April 13, 2015

**Subject: Century Tire Plaza – 195 Kennebec Street
Project ID# 2015-027
Review Comments Received April 8, 2015**

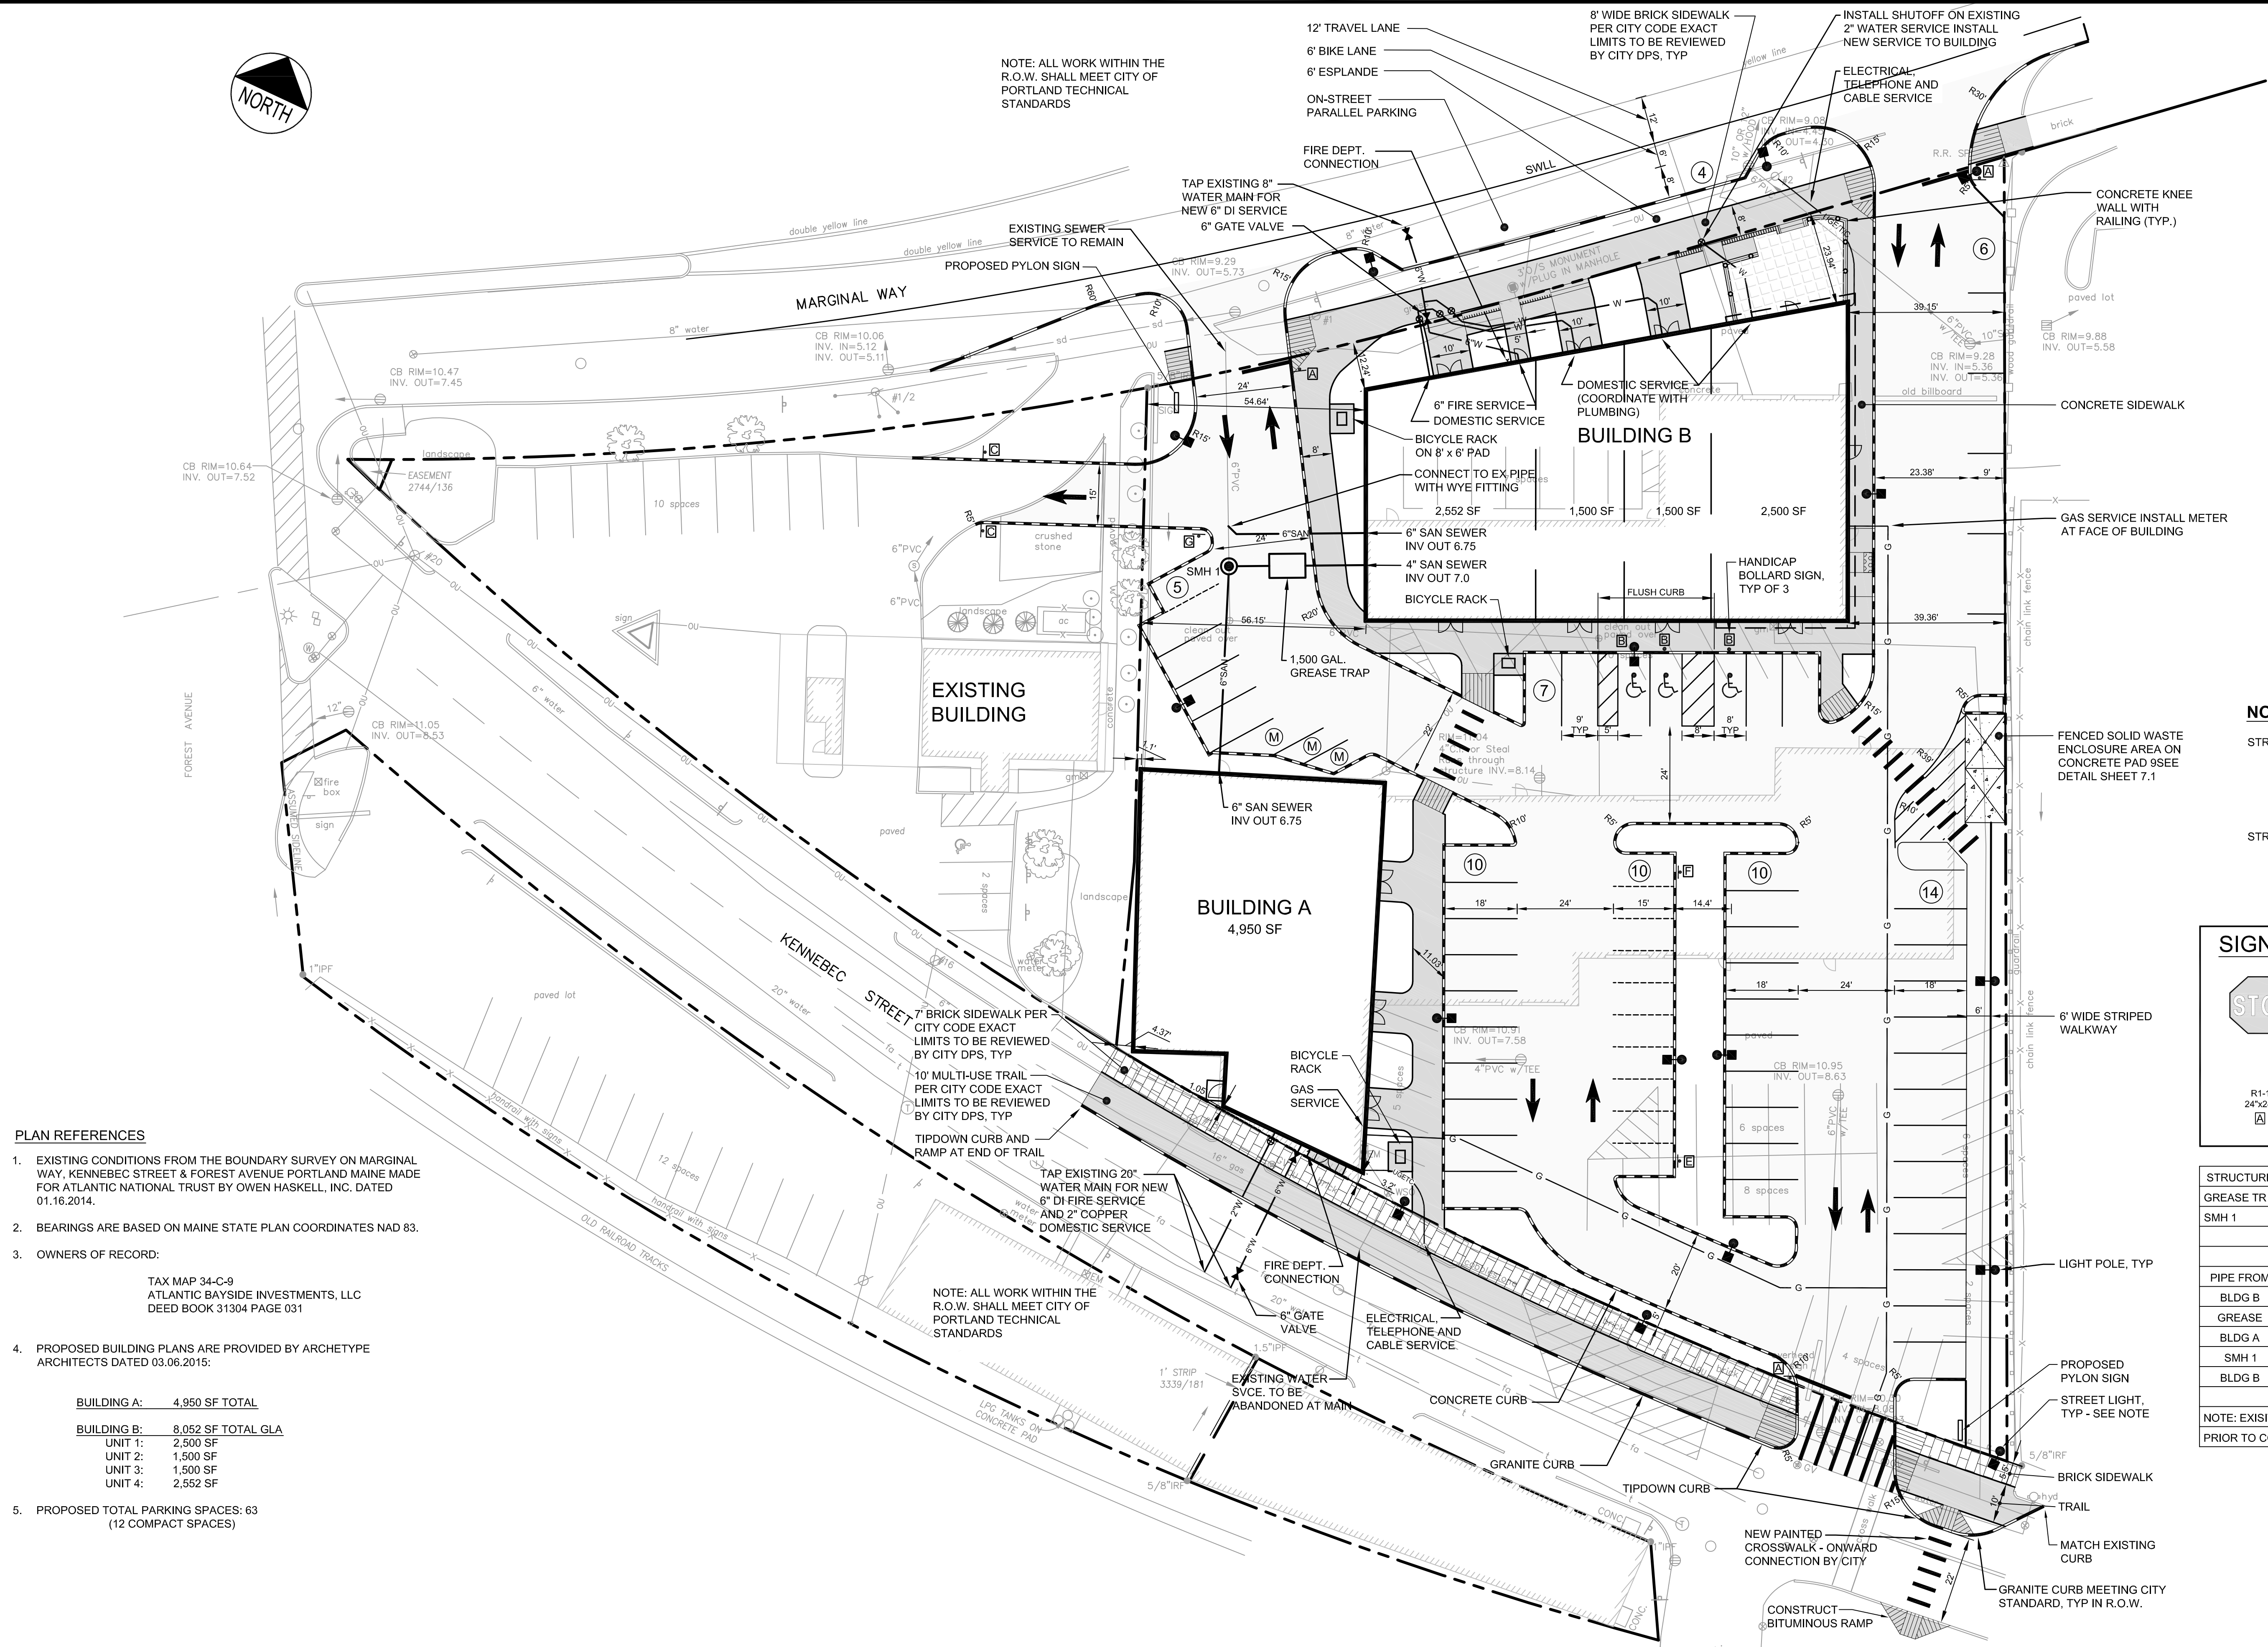
As requested, the plans have been revised to show a connection from existing Catch Basin A to new Catch Basin 3, which will discharge to Marginal Way. Additional notes are required regarding the abandonment of the pipe between Existing Catch Basin A and the existing catch basin in Kennebec Street.

The pipe and catch basin penetrations should be capped at Catch Basin A and at the connection in Kennebec Street; and preferably the pipe is removed or infilled with a flowable fill.

- *A curb extension shall be provided on Kennebec Street at the location of the sidewalk ramp/crosswalk such that the handicap ramp is not located within the 10-foot path area. The applicant shall submit plans for review and approval by the City.*

The plans should incorporate a full ADA compliant crosswalk on Kennebec Street between the site and Brattle Street (this crosswalk currently exists). Status: The plans should also include the construction of a ADA compliant ramp on the south side of the crosswalk on Kennebec Street. Plans shall be provided to the City for review and approval.

Please add notes to the plan denoting the street light specifications for both Marginal Way and Kennebec. This will help our inspectors during construction.

Notes have been added on the revised plans stating that the pipe penetrations into the referenced structures will be capped and sealed, as requested.

- The applicant will provide documentation to assist in support of the City's proposed Traffic Schedule changes, as requested.
- The curb line on Kennebec Street has been extended to remove the handicap ramp from the multi-use trail, as requested.

A ramp has been added on the south side of Kennebec Street.

A note has been added to the Site Layout and Utility Plan with the model numbers for the street lights and referencing the City Technical Manual Detail.

PROJECT	CENTURY TIRE PLAZA 195 KENNEBEC STREET, PORTLAND, ME		
SHEET TITLE	EROSION AND SEDIMENT CONTROL PLAN		
CLIENT	NORTHLAND ENTERPRISES, LLC

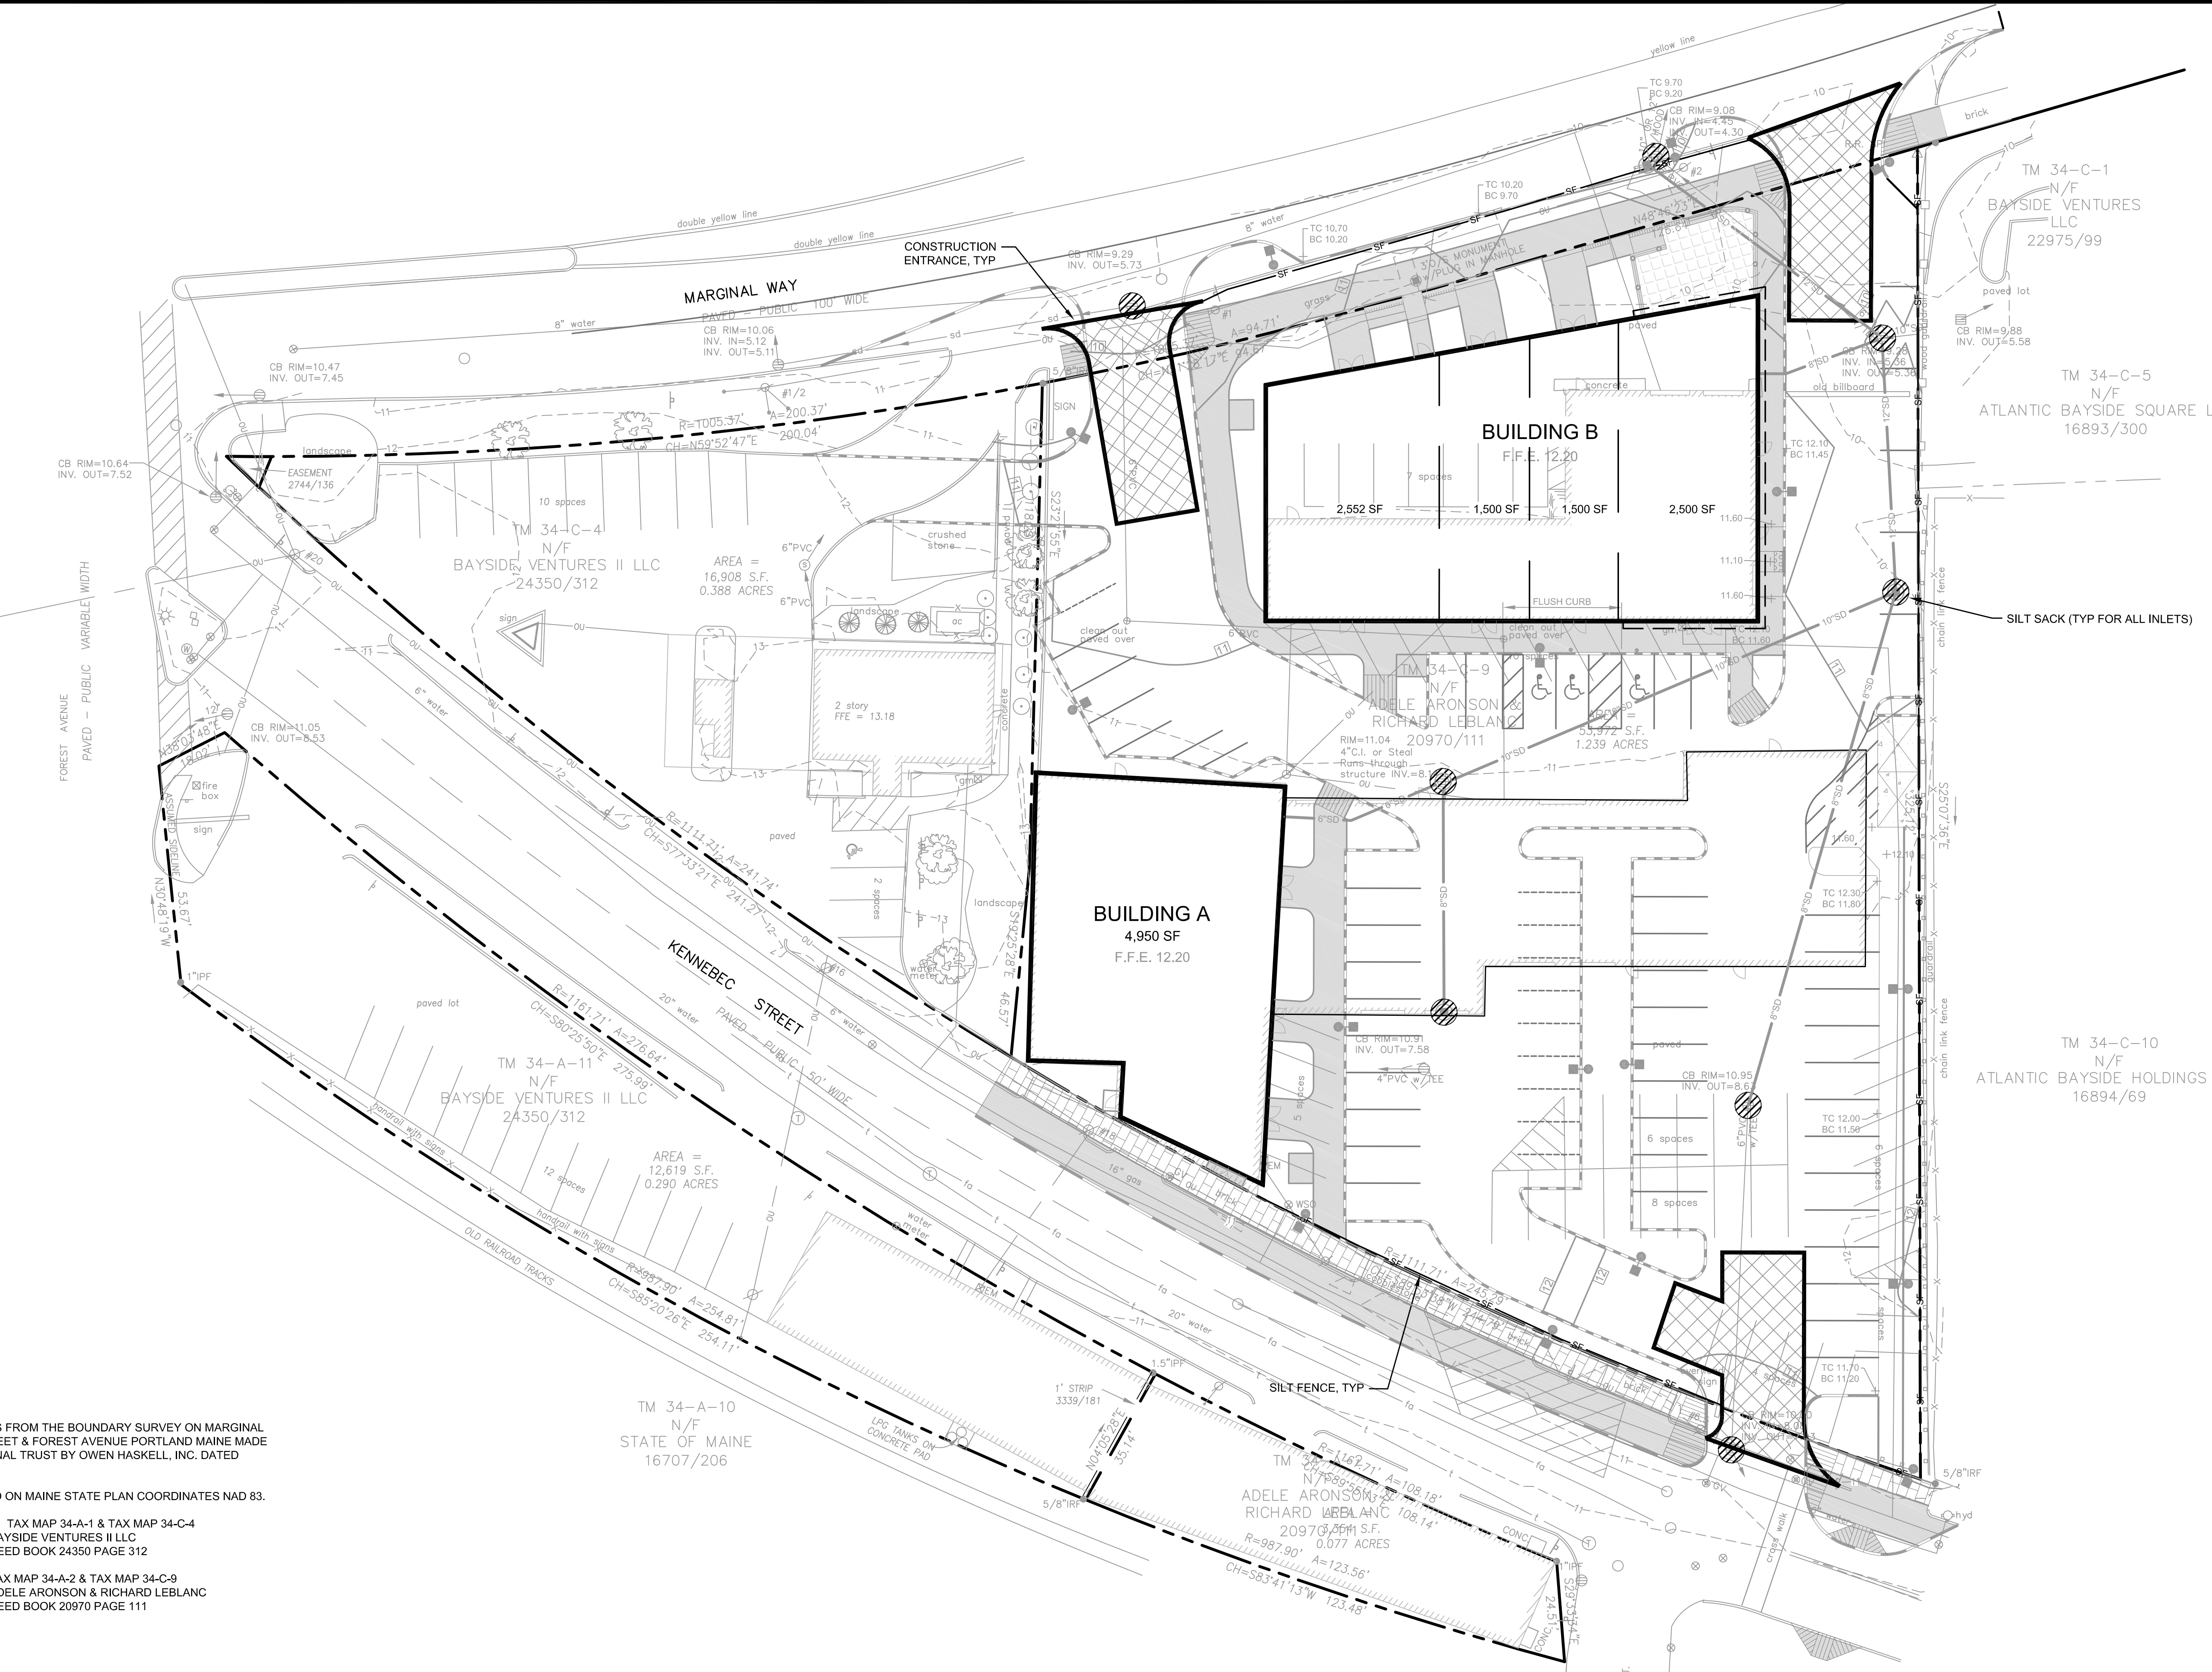
The revised Sheet C-5.0 Erosion and Sediment Control Plan no longer includes the erosion and sediment control practices that were identified on the originally submitted plan. This plan should be revised to reflect the original submittal.

The erosion and sediment control measures were shown on Plan Sheet 5.0, revised 04/01/15. This sheet has been reissued, dated 04/10/15 to reflect the layout changes requested in other comments.
